July 9, 1980
TLL 283

Three Mile Island Nuclear Station, Unit II (TMI-2)
Operating License No. DPR-73
Docket No. 50-320
Submerged Demineralizer System Technical Evaluation Report

Your letter NRC/TMI-80-89, dated May 16, 1980, requested additional information to enable your evaluation of the subject report.

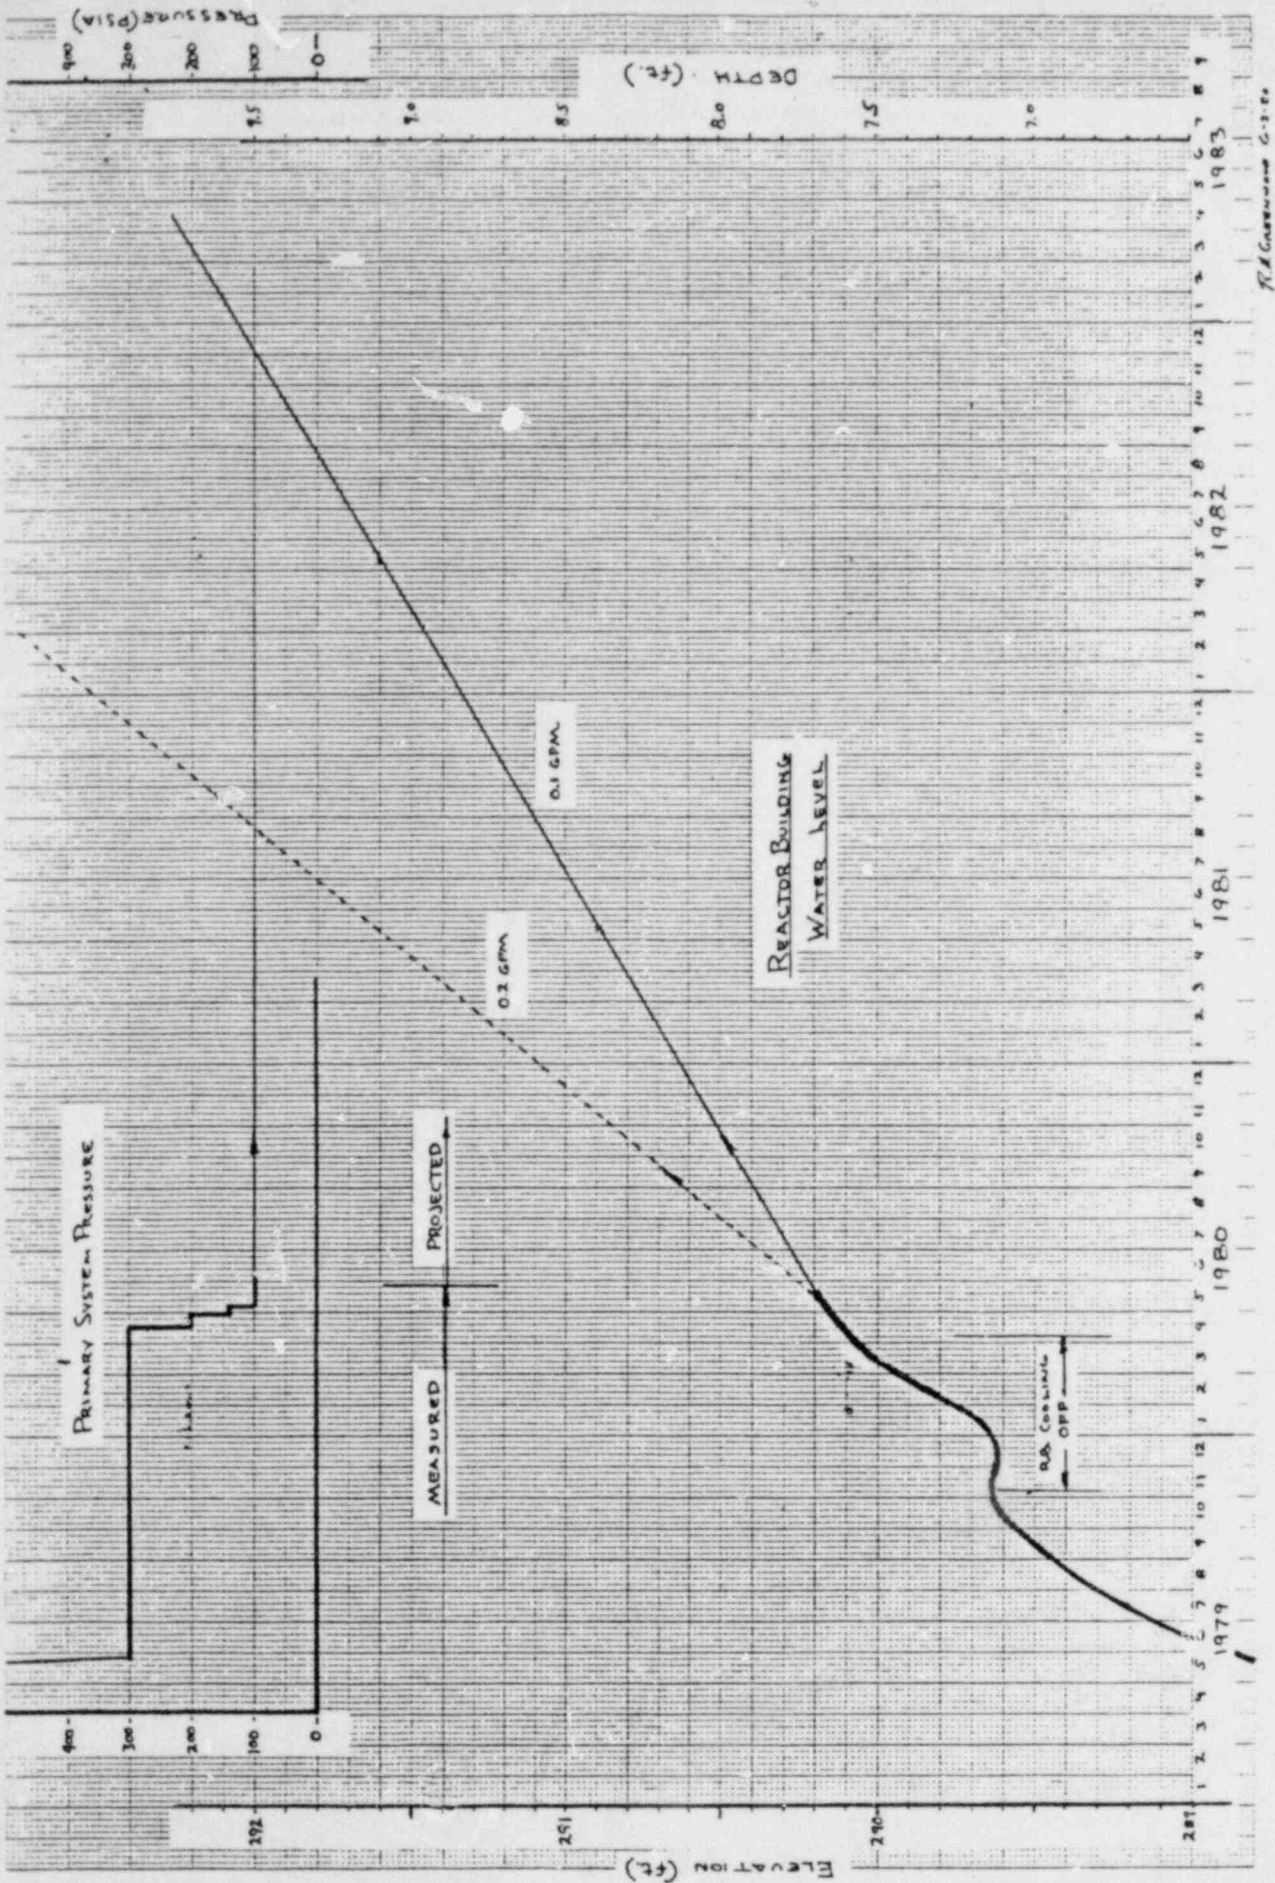
Based on past experience, project the Reactor Building water level for the next two years and list the critical instruments that may be affected by the water level you projected.

2.1 The projected water level in the Reactor Building for July 1, 1982 is 291.7 feet or a depth of 9.2 feet from the RB floor. This projection is based on the current water depth of 7.7 feet (as of May 15, 1980) with an inflow leakage of ~ 0.1 gpm from the Reactor Coolant System (RCS). This inflow leakage rate has been detected during the period of time that the RCS has been maintained at a pressure of ~ 100 psi (DVM).

As a bounding (worst case) estimate - a higher leak rate was also studied. An inflow leakage of 0.2 gpm was indicated from sump level measurements during the time that the RCS was maintained at ~ 300 psi. Thus, an upper elevation of the water depth could be 10.7 feet by July 1982 should the RCS pressure be returned to 300 psi. The projected depth at the postulated leakage rate of 0.2 gpm would be 293.2 feet.

A plot of the measured Reactor Building water level indicates that a fluctuation can be expected from deactivation of the Reactor Building Cooling Water. This type of action allows the R.B. humidity level to approach 100%. As condensation occurs on all components that are cooler than air, the sump water is transferred to higher elevation collection areas. When these collection areas become saturated or filled, the accumulation rate in the sump resumes at a rate matching the inflow leakage rate. When the RB cooling water is activated the collected water evaporates due to the lower humidity and is returned to the sump by condensing at the cooling coils which are drained into the sump. The type of water accumulation fluctuation shown by this figure is expected to occur seasonally, thus, the projected straight line increase of 0.1 gpm will fluctuate depending on RB Cooling System operation, but the average leakage from the RCS will be 0.1 gpm.

Fig. 10. Small-column loading tests of ion exchange materials with synthetic TMI-2 primary loop water and ^{137}Cs tracer.

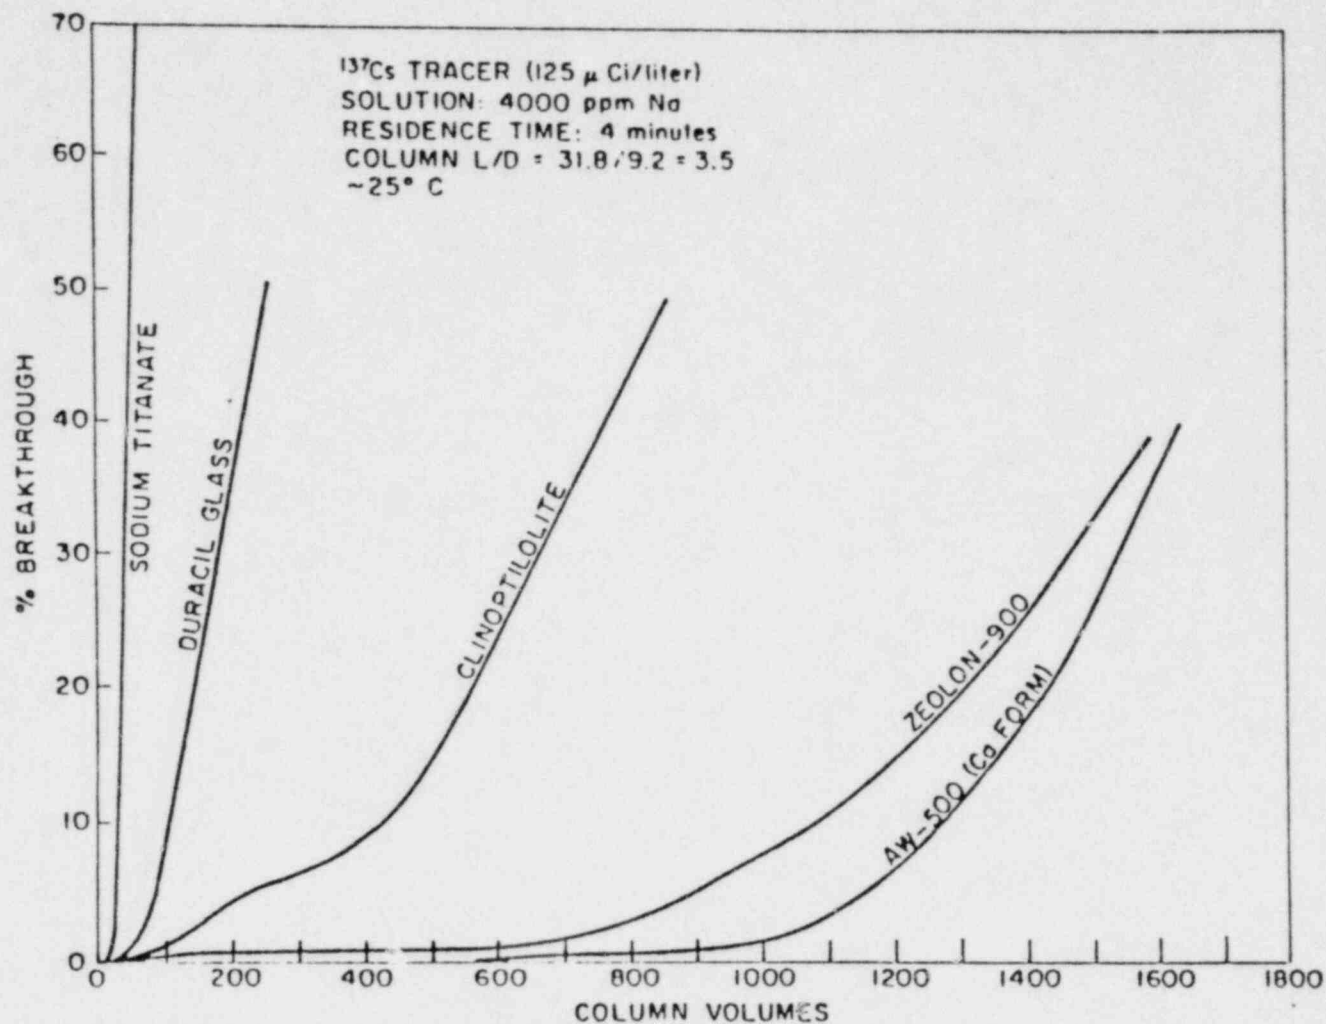
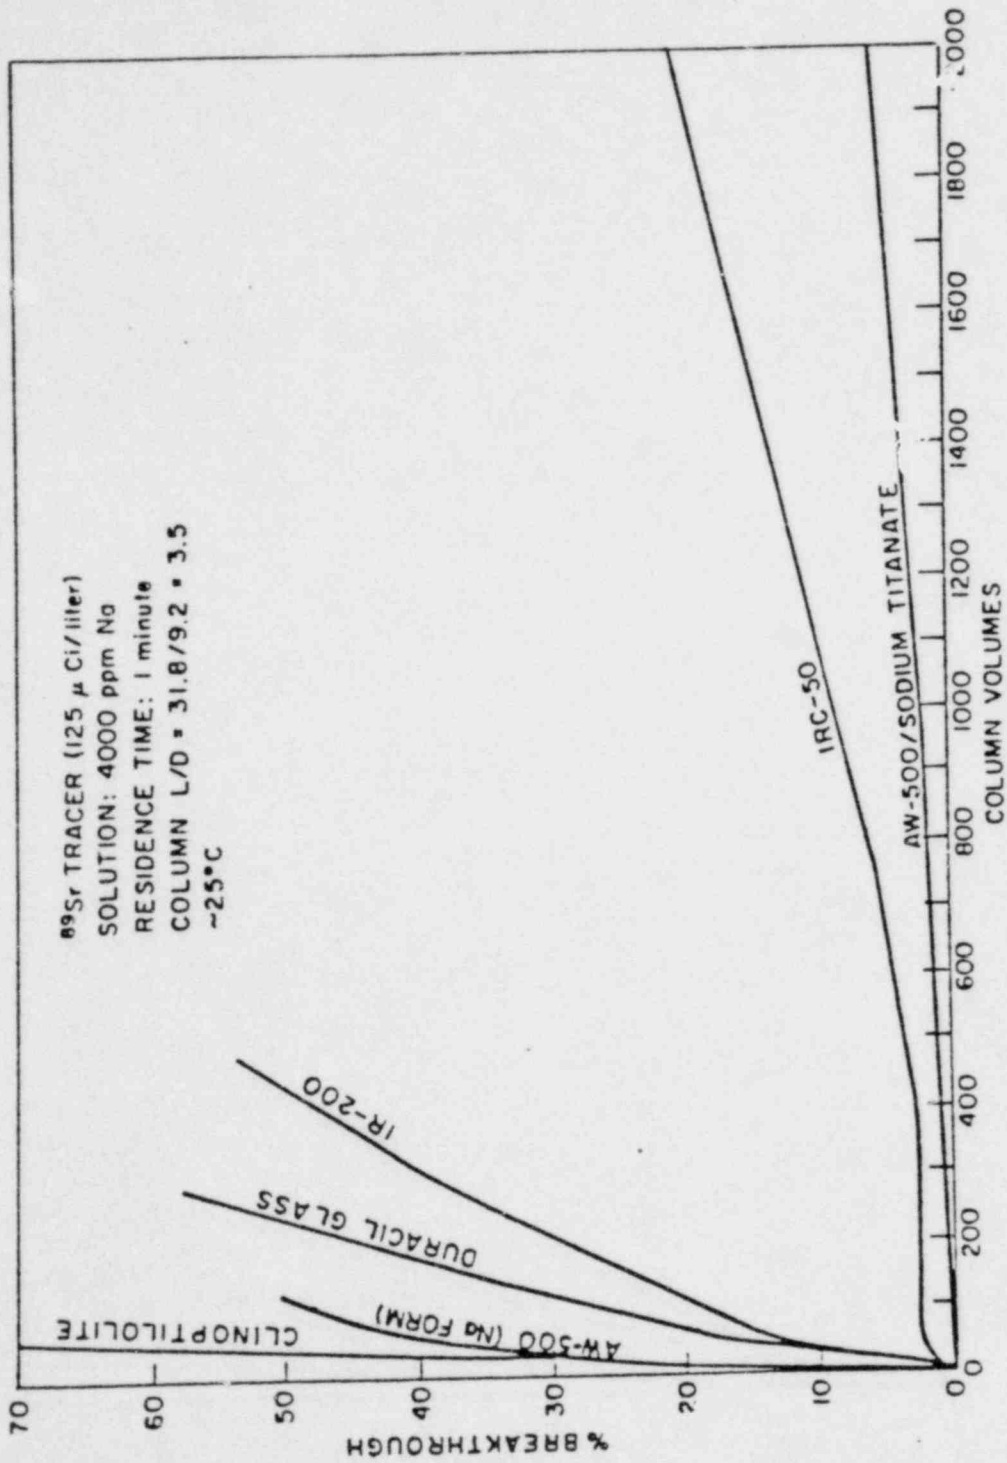
You state that the results of recent experimental work with simulated and actual water samples from TMI-II were used to support the selection of specific ion exchanger materials for the SDS. Provide a copy of such test results to the NRC for review.

The attachment to this response is extracted from a preliminary report generated by the Oak Ridge National Laboratory. This report is entitled "Post-Accident Cleanup of Radioactivity at the Three Mile Island Nuclear Power Station", ORNL/TM-7081. This attachment presents not only the report of specific ion exchanger selection tests, but the development of the SDS processing scheme. The final report will be available in August, 1980.
